Section 75w Modification of
Concept Approval MP 06_0085

Rainbow Beach Estate

Lot 1 DP 1193553 (part of former Lot 1232 DP 1142133),
Lots 1, 2, 3 and 4 DP 1150758 and Lot 5 DP 25886,
Ocean Drive, Lake Cathie

May 2016

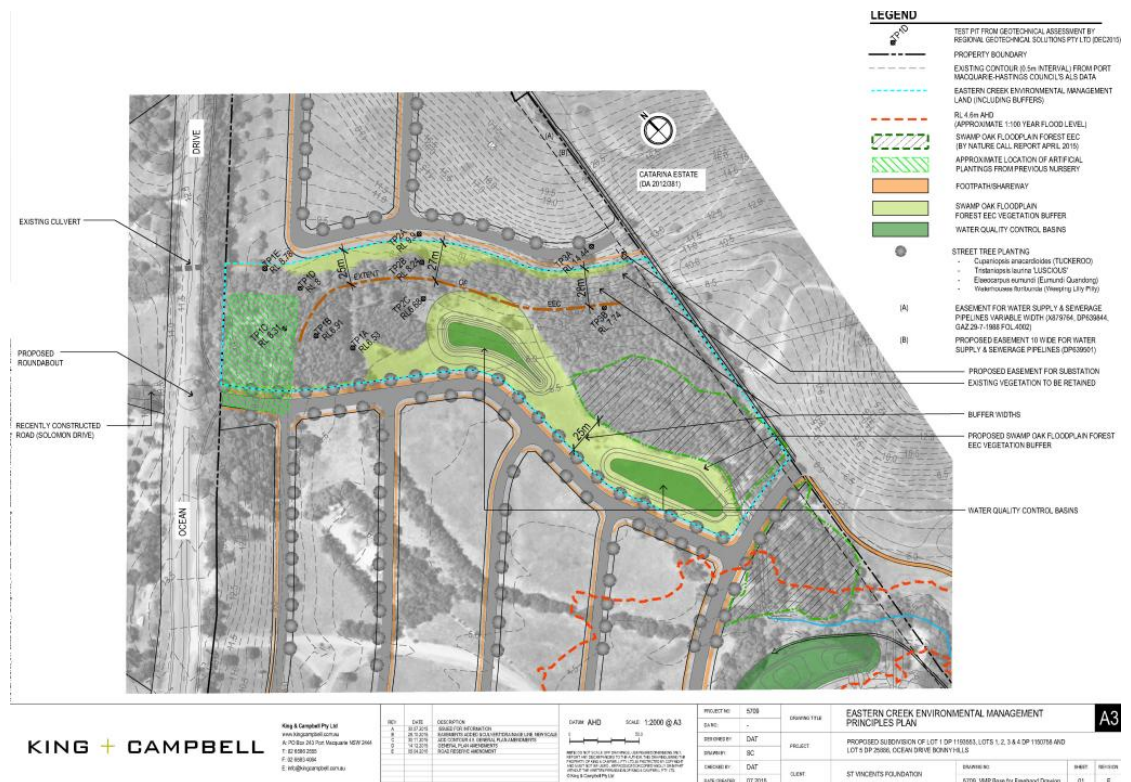
In consideration of the above environmental assessments and following consultation with OEH and Council, the Eastern Creek Environmental Management Principles Plan has been prepared. The plan is included as Attachment 09 to this submission and an extract of the plan is provided below.

The plan illustrates the agreed extent of the SOFF EEC in this location. The minimum biodiversity enrichment/fully vegetated buffer of 25 metres required by Condition B2 is then provided from this extent.

To ensure that the Concept Approval is consistent with the Eastern Creek Environmental Management Principles Plan, it is proposed to amend the terms of Condition B2 of the approval. The proposed amendments to Condition B2 are addressed in Section 3.1.1 of this submission.

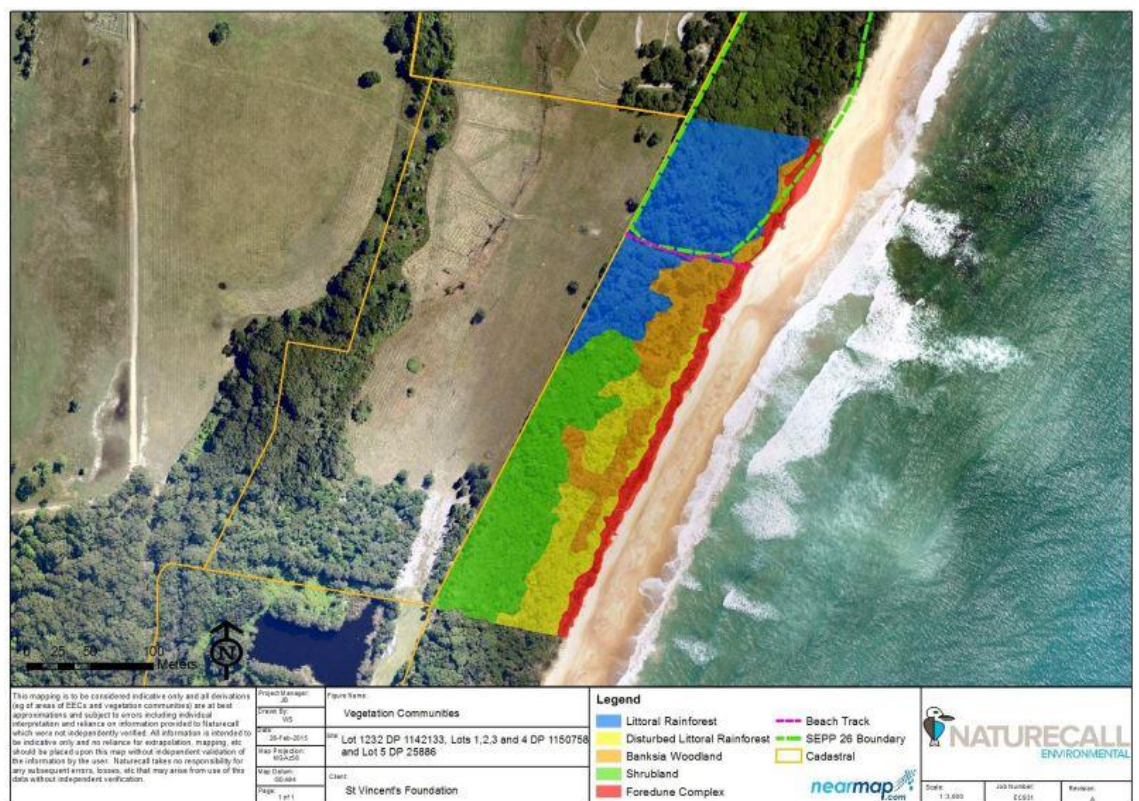
The following is noted with respect to the subject site and the conditions associated with the adjoining lands to the north:

- SEPP 26 Littoral Rainforest No.116 adjoins the northern extent of the eastern boundary of the subject land for a distance of approximately 95m and does not extend on to the subject lands. Conversely SEPP 26 Littoral Rainforest No.116 adjoins the entire length of the eastern boundary of the MP 07_0010 land and in some instances encroaches onto the private lands;

- Littoral rainforest vegetation (i.e.; not mapped as SEPP 26) is not present on the subject land. Conversely, existing littoral rainforest vegetation is mapped within the MP 07_0010 land;

- The subject land has been zoned residential for some time and the provisions of SEPP 26 are therefore not applicable. Conversely, consideration of the MP 07_0010 land with respect to the biodiversity enrichment/fully vegetated area was undertaken when the lands were zoned Rural 1(a1) and accordingly, the provisions of SEPP 26 were applicable;

- The existing edge of SEPP 26 Littoral Rainforest No.116 adjacent to the subject land is uniform and has been described by NatureCall as being relatively intact and closed. Conversely, the edge of the existing littoral rainforest vegetation on the MP 07_0010 land is uneven and decreasing the edge-to-area ratio through smoothing this edge was a paramount consideration.

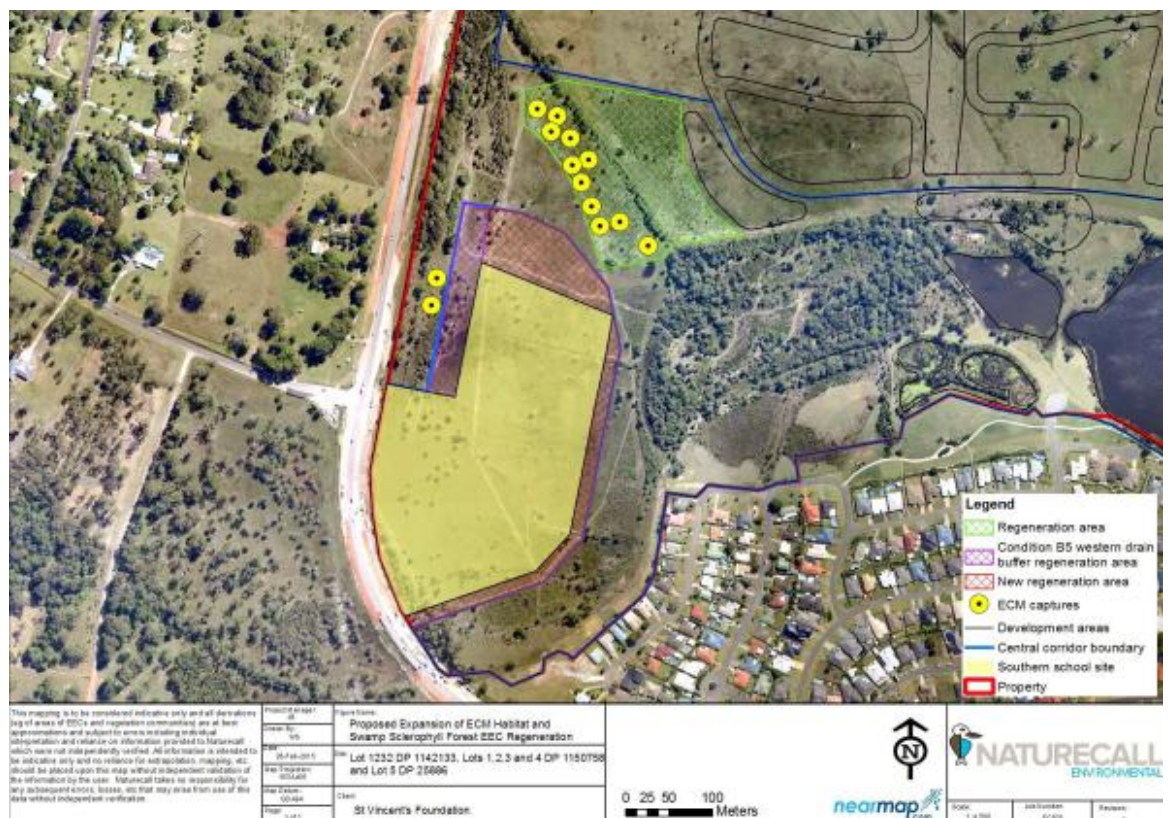
Condition B5 of the Concept Approval required that a modification be made to the southern school site to provide for a minimum 30m wide buffer to the western drain and regeneration area (see Plan I in Attachment 02 and Attachment 05).

Condition B5 is as follows:

The identified Common Planigale and Eastern Chestnut Mouse habitat area (the entire drain and a fully vegetated buffer zone of at least 30m to the east as recorded in Appendix 6 of the Environmental Assessment) west of the southern school site is excluded from any filling, clearing etc. This area is to be collectively fenced off, revegetated with southwest dry sclerophyll/swamp forests (as per the Environmental Land Use Management Plan), and the total area regenerated and managed appropriately for these species to maximise the potential viability of these small populations. These excluded areas must be fenced off and incorporated into the central corridor as shown in Plan I.
